DARWIN CITY COUNCIL

TOWN PLANNING COMMITTEE

WEDNESDAY 3 JUNE 2009

10.1	Development Application Lot 1756 (25) Daly Street, Darwin 40 x 3 Bedroom Multiple Dwellings & Offices in a 12 Storey Building Including Car Parking in the Basement and Levels 1 to 3.....	6

LANDSCAPE CONCEPT - GROUND FLOOR

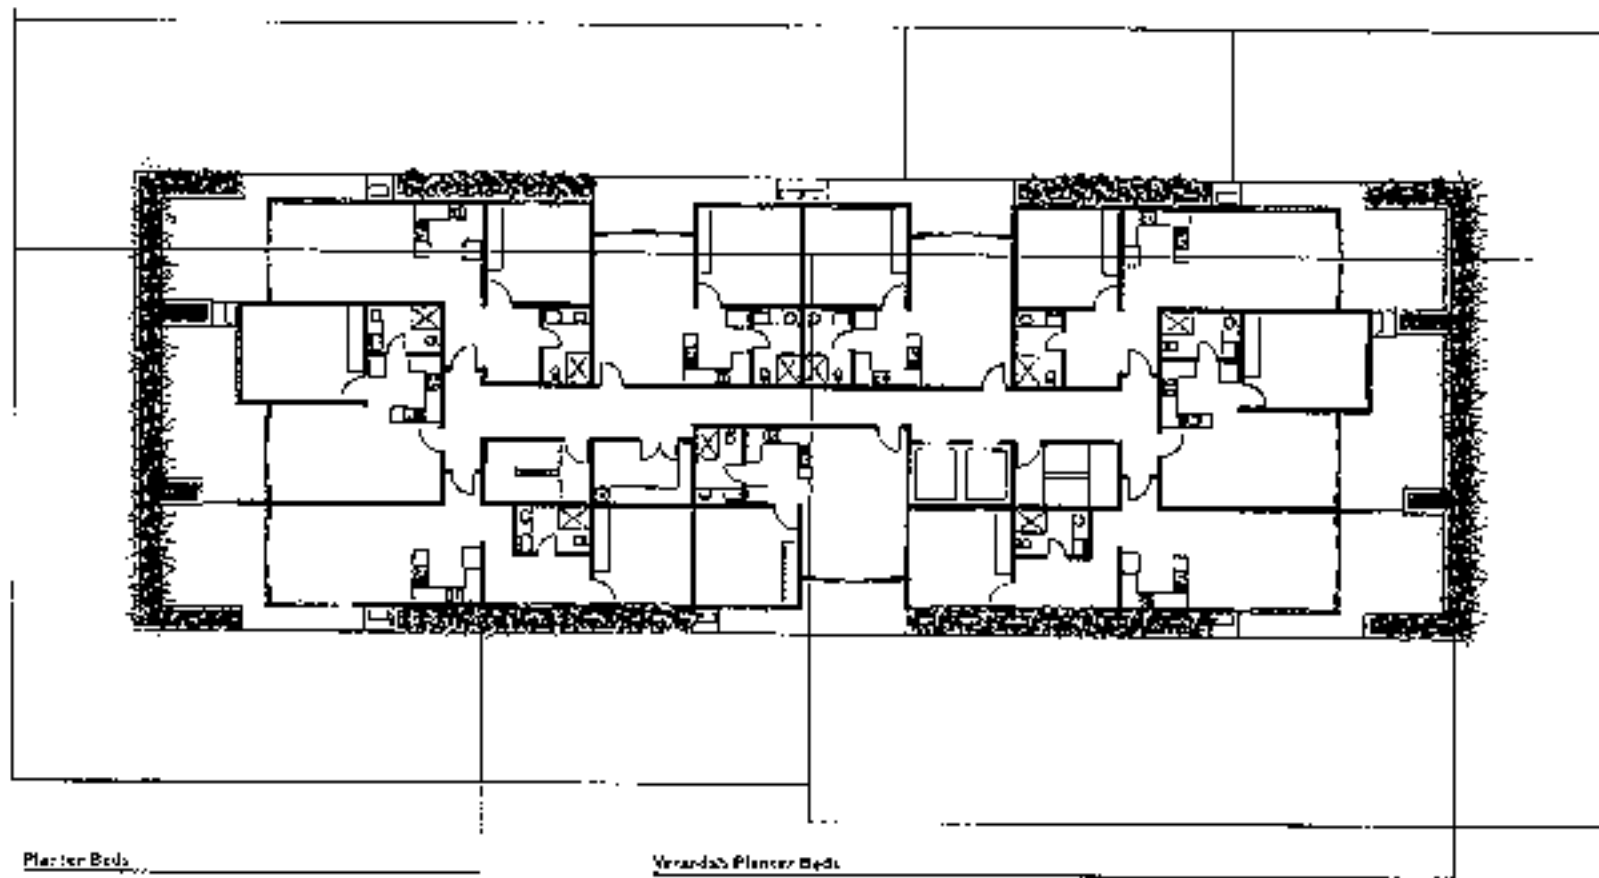
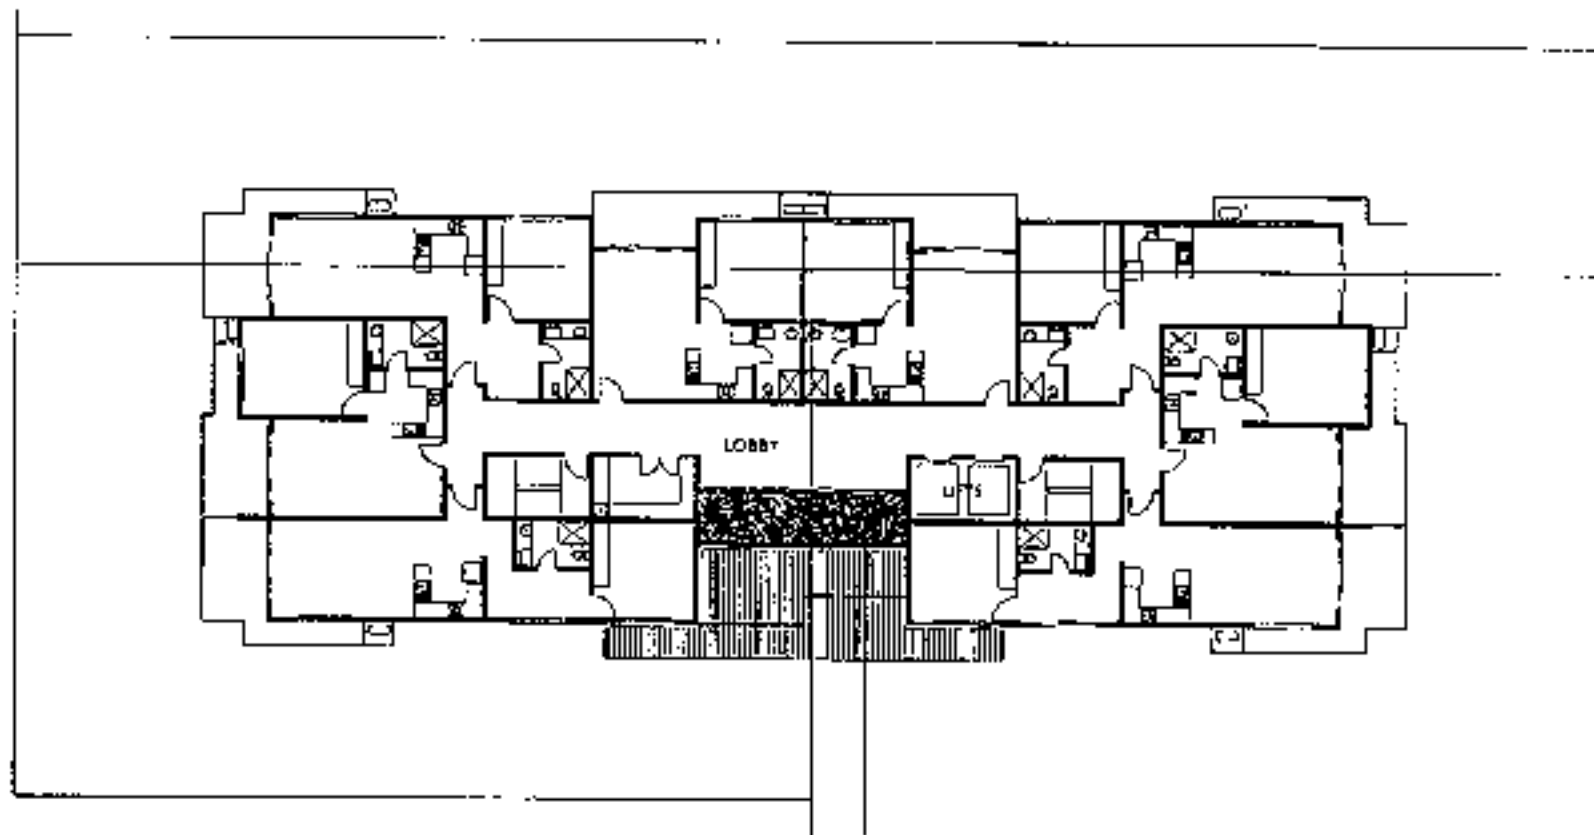
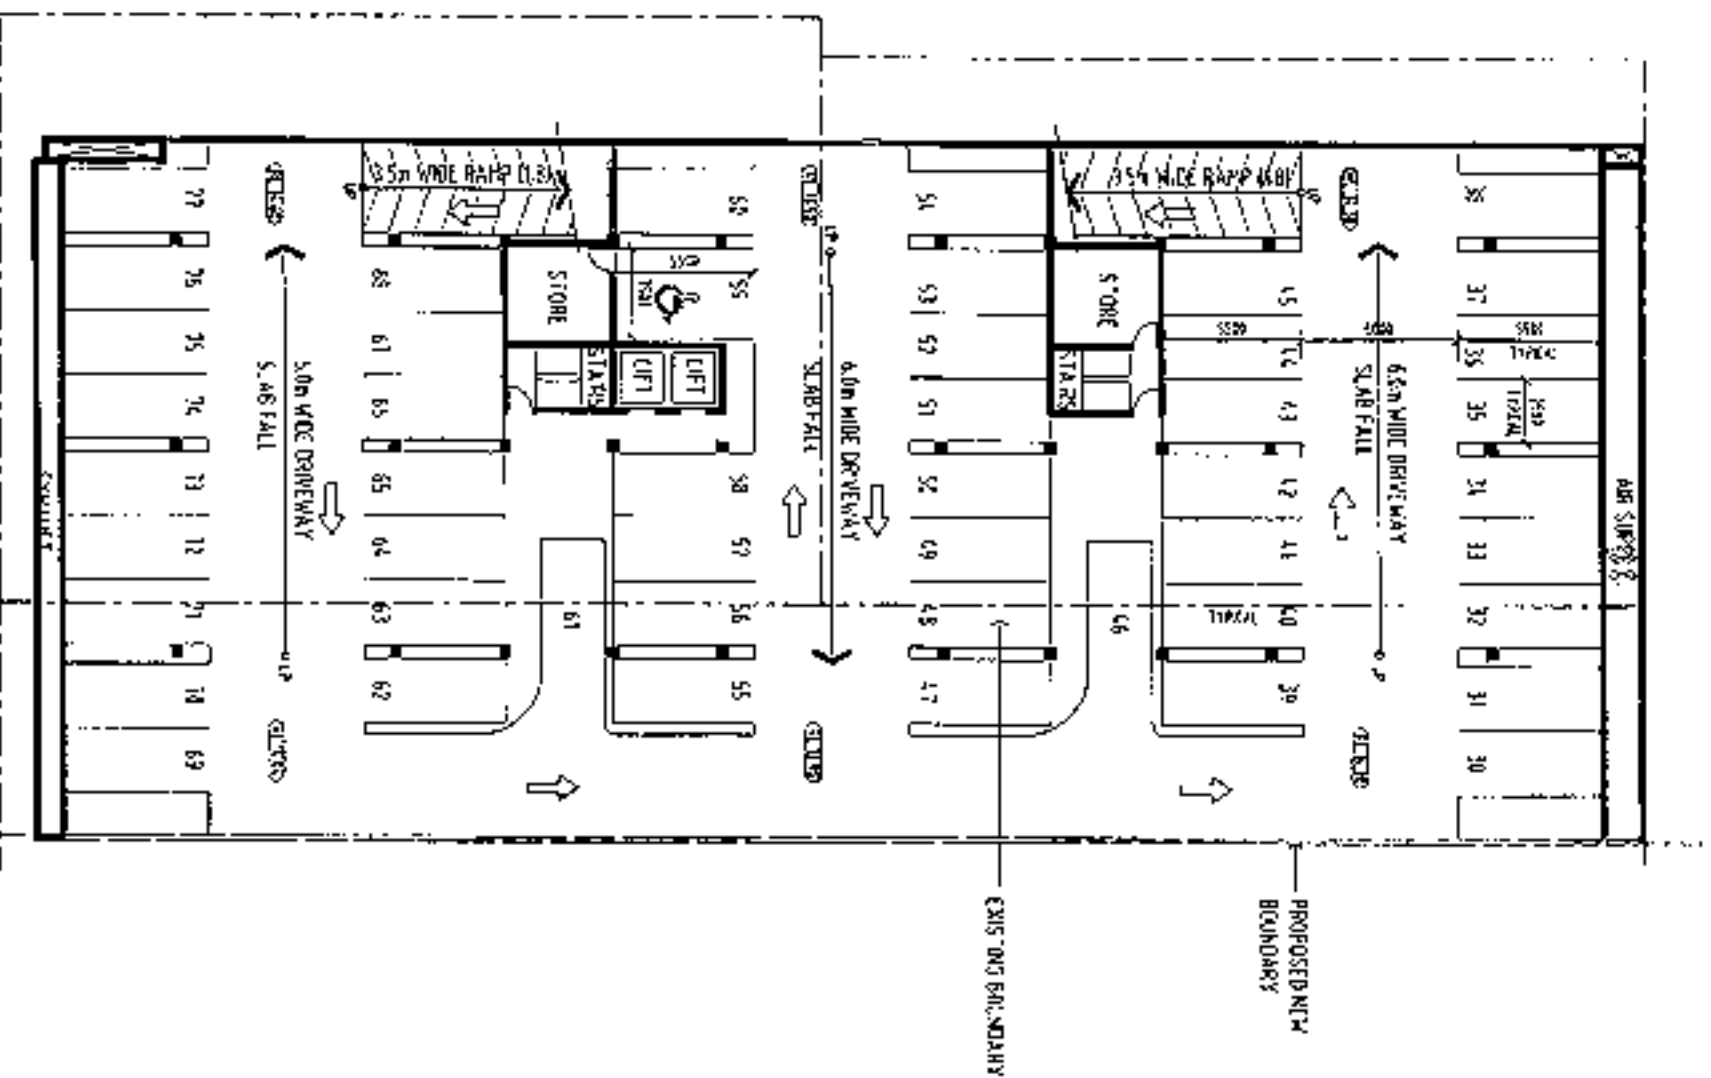
Doctors Gully Road Street Frontage	Setback Required	Setback Provided	Compliance
Pool Deck	2.5m + 0.5m = 3.0m	1.7m to car park wall shown on Ground Level floor plan	no
1 st floor	2.5m + 0.5m = 3.0m	5.6m to balcony wall	yes
2 nd & 3 rd floors	2.5m + 0.5m = 3.0m	8.2m to balcony wall	yes
4 th to 8 th floors	2.5m + 0.5m + 1.5m (additional storey) = 4.5m	8.2m to balcony wall	yes

The proposal does not meet the setback requirements of the NT Planning Scheme on the Mitchell Street frontage but does meet them on the Doctors Gully frontage. The Development is built to the property boundary on the Mitchell Street frontage and the applicant claims that this fulfils the requirement to provide an active pedestrian oriented street frontage.

The average setback required by the NT Planning Scheme for the North Western boundary of the site is 10.2 metres. The proposal provides an average setback of 7 metres on this boundary. The average setback required by the NT Planning Scheme for the South Eastern boundary is also 10.2 metres. Again the proposal falls short in the provision of 7 metres setback on this boundary.

If approved Council requests that a traffic management plan be prepared as a condition of the development permit to the satisfaction of the General Manager of Infrastructure, Darwin City Council.
